Request for Additional Information No. 69 (773), Revision 0

U. S. EPR Standard Design Certification

Docket No. 52-020

SRP Section: 06.02.05 - Combustible Gas Control in Containment

Figure 06.02.05-1-3—Global Hydrogen Concentration (Mixing Dampers)

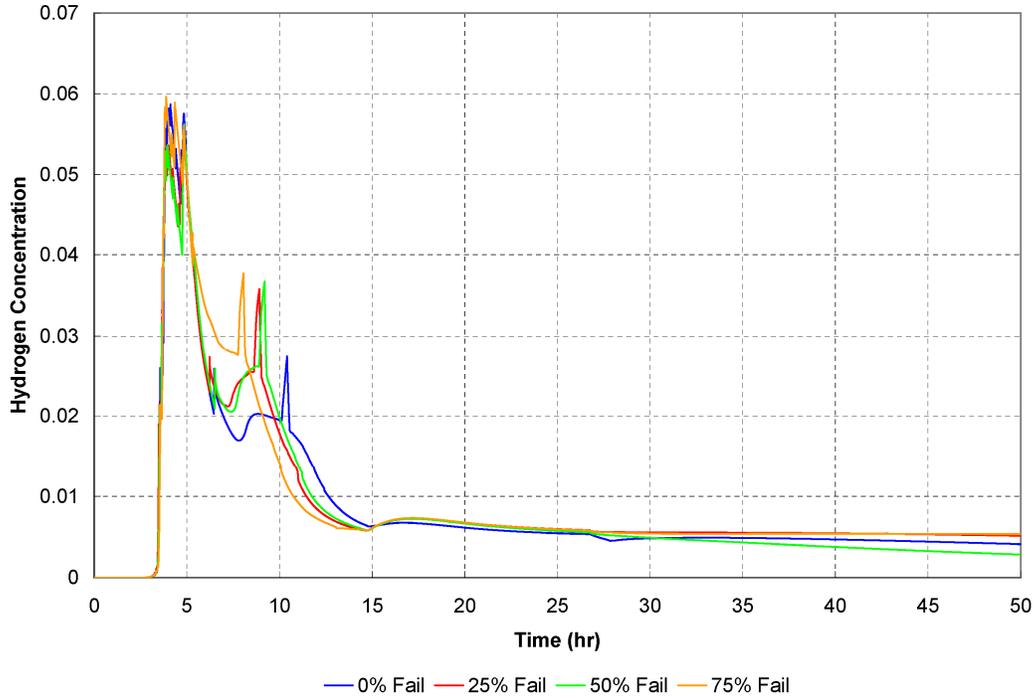
To evaluate the mixing dampers related to hydrogen concentration, several MAAP calculations were completed with 25 percent, 50 percent, and 75 percent of the mixing dampers failing to open. Figure 06.02.05-1-3 shows the global hydrogen concentration for 0 percent, 25 percent, 50 percent, and 75 percent failure of the mixing dampers. The global hydrogen concentration remains below 10 percent for all cases. The compartments affected by the mixing dampers failing would remain open to containment because PARs and rupture and convection foils are also located in affected compartments. Figure 06.02.05-1-4 shows, for 75 percent mixing damper failure, the hydrogen concentration for containment nodes. This figure shows an increase and decrease in every node, which is evidence of hydrogen distribution and mixing throughout the U.S. EPR containment. Figure 06.02.05-1-4 shows local hydrogen concentrations from the MAAP model for the IRWST (NFH2RB(2)), lower equipment room for broken loop (NFH2RB(3)), lower equipment rooms for unbroken loop (NFRH2RB(4)), middle equipment room for broken loop (NFH2RB(5)), middle equipment rooms for unbroken loop (NFRH2RB(6)), upper equipment room for broken loop (NFH2RB(7)), reactor cavity (NFH2RB(9)), upper equipment rooms for unbroken loop (NFH2RB(10)), surge line (NFH2RB(11)), pressurizer (NFH2RB(12)), components (NFH2RB(13)), first stage steam generator blowdown cooler (NFH2RB(14)) containment nodes.

Figure 06.02.05-2-1—Hydrogen Concentration for All Compartments

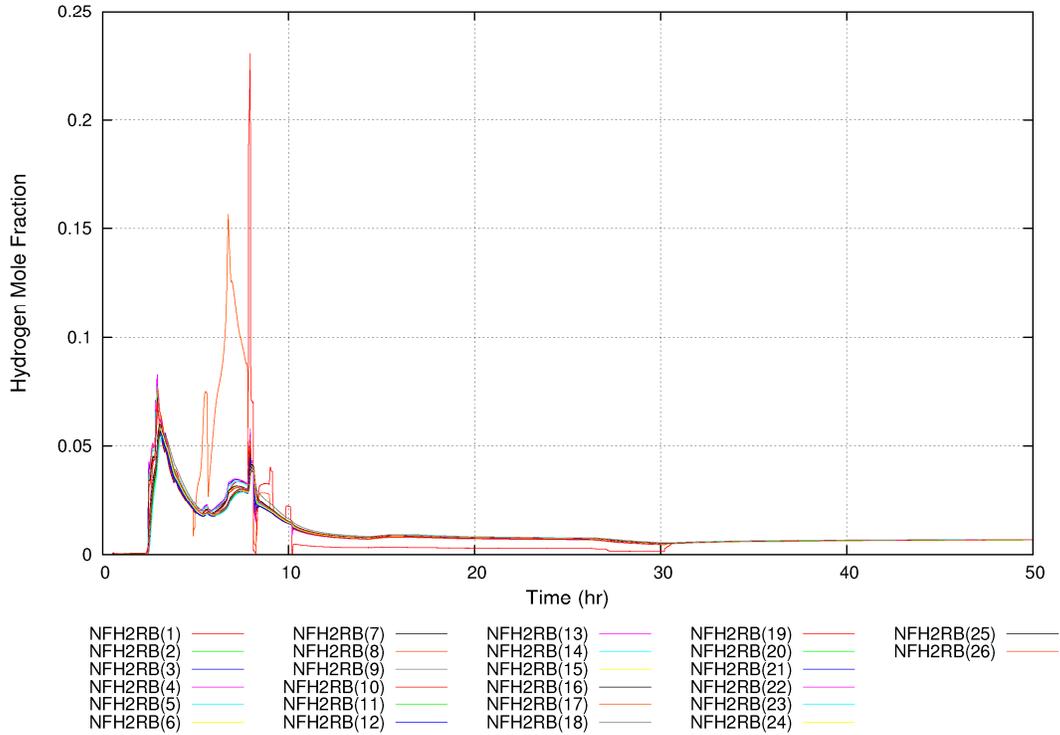
FSAR, Tier 2, section 19.2.4.4.1.3, Hydrogen Distribution, and FSAR Figure 19.2-5, Hydrogen Concentrations Through the US EPR Containment, address hydrogen concentration results in various compartments following a severe accident. Since Figure 19.2-5 “excludes” the compartments where release of hydrogen is predominant, provide the hydrogen concentration in the steam generator and reactor coolant pump rooms, the reactor pit and the spreading room for the same 50 hour time frame.

U.S. EPR FSAR Tier 2, Figure 19.2-5 shows the hydrogen concentrations in various compartments within the containment. The text referring to this figure incorrectly indicates that the figure excludes the equipment rooms (pumps and steam generators). U.S. EPR FSAR Tier 2, Figure 19.2-5 includes the equipment rooms (pumps and steam generators). The spreading room and steam chimney and reactor pit compartments were excluded, as the hydrogen released in these compartments, through the molten corium-concrete interaction (MCCI) process, occurs at temperatures above the auto-ignition temperature. Therefore, the hydrogen immediately burns upon generation. The hydrogen concentration in these compartments has little meaning. The hydrogen concentration of those compartments has been included in Figure 06.02.05-2-1, which shows the hydrogen concentration in all compartments of the MAAP model.

Figure 06.02.05-4-1: Tolerance Limit Plot for Containment Pressure

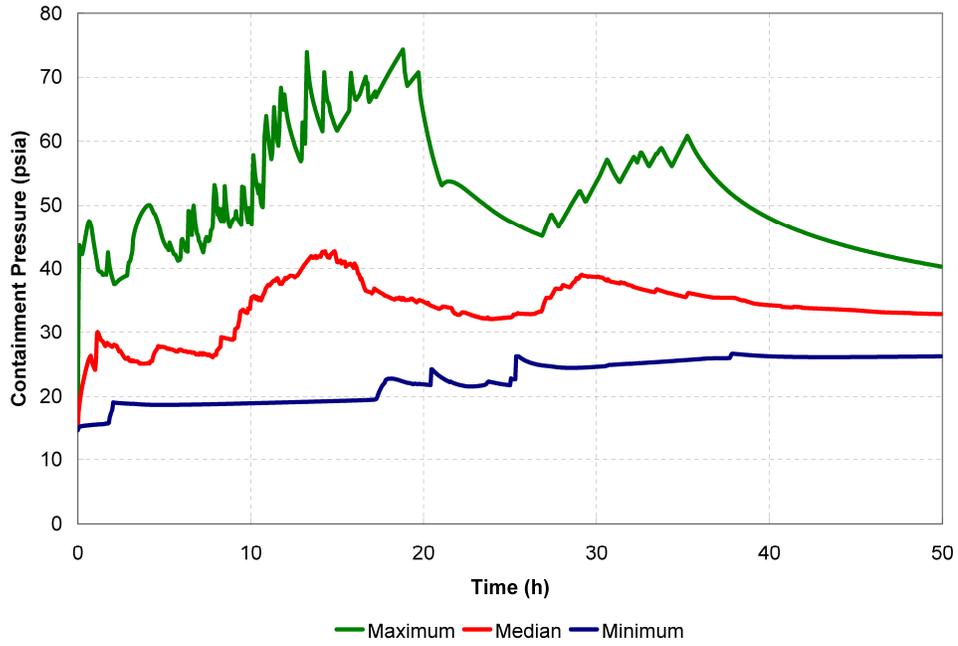
US EPR DCD Tier 2 Figure 19.2-7, the Tolerance Limit Plot for AICC Pressure shows the global maximum pressure is 105 psia. Confirm that this corresponds to P_{g2} for the Factored Load combination above. Provide P_{g1} and P_{g2} (if produced during the severe accident). Compare this total load combination to the ultimate capacity pressure of 119 psig (Tier 2, Table 3.8-6, Containment Ultimate Pressure Capacity).

U.S. EPR FSAR Tier 2, Figure 19.2-7 shows the containment maximum global pressure as 105 psia. This value is inclusive of both the pressure resulting from an accident that releases hydrogen generated from 100 percent fuel clad-metal water reaction (P_{g1}) and the pressure resulting from uncontrolled hydrogen burning (P_{g2}). The pressure resulting from severe accidents without combustion, P_{g1} , is displayed in Figure 06.02.05-4-1 and is the containment pressure tolerance limit. The maximum pressure is shown to be 75 psia. Subtracting P_{g2} (75 psia) from the combination of $P_{g1} + P_{g2}$ (105 psia) yields a P_{g1} of 30 psia.

The factored load combination consists of $D + P_{g1} + (P_{g2} \text{ or } P_{g3})$, the effective pressure on containment is generated from $P_{g1} + P_{g2}$ and as previously stated, is taken as 105 psia. Subtracting the atmospheric pressure of 14.7 psi results in a maximum global pressure value of 90.3 psig. This pressure value is smaller than the ultimate capacity pressure that containment can withstand of 119 psig as stated in U.S. EPR FSAR Tier 2, Table 3.8-6 and is therefore bounded by the ultimate capacity of containment.
